SERVICE BULLETIN

APPLICABILITY: 2015 WRX and STI Models

NUMBER: 12-186-15

SUBJECT: Paint Chipping between Hood Grille (Scoop)
and Hood

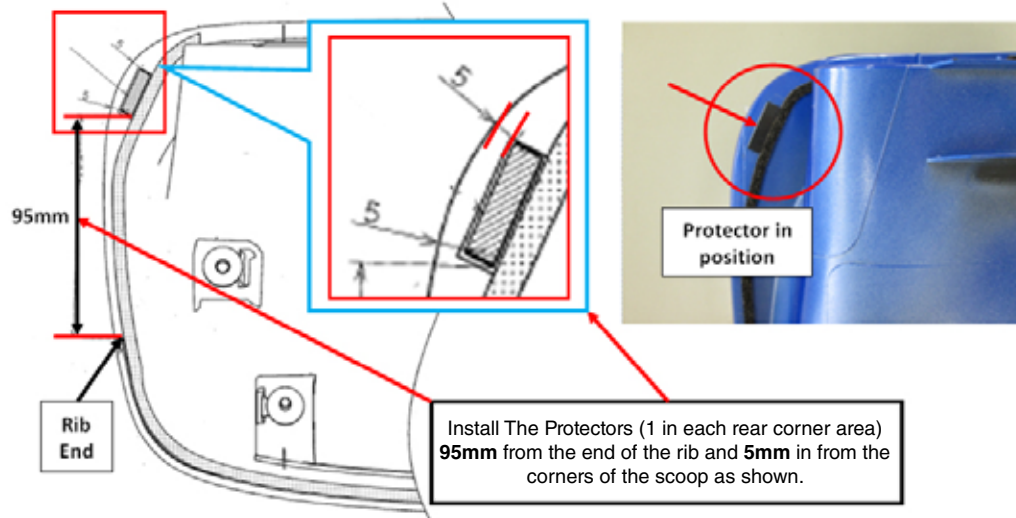
This bulletin announces a repair procedure to address customer concerns of the hood scoop scrubbing the finish of the hood panel in the areas shown in the photo below. Due to different expansion rates between the metal hood panel and the resin material used for the hood scoop, the edges of the scoop's rear corners may come in contact with the hood panel and abrade the finish. The procedure involves installation of 2 pieces of self-adhesive rubberized material to act as protectors (insulators) between the scoop and hood panel.

- Using the illustrations above as a guide, clean the areas where the protectors will be applied with a mild solvent on a clean shop cloth.
- After drying the cleaned areas completely, **CAREFULLY** measure and mark the locations where the protectors will be installed.
- Peel the adhesive backing and apply the protectors to the scoop.
- Reinstall the scoop into the hood panel in reverse order of removal. Torque the retaining nuts to 39 inch-pounds.
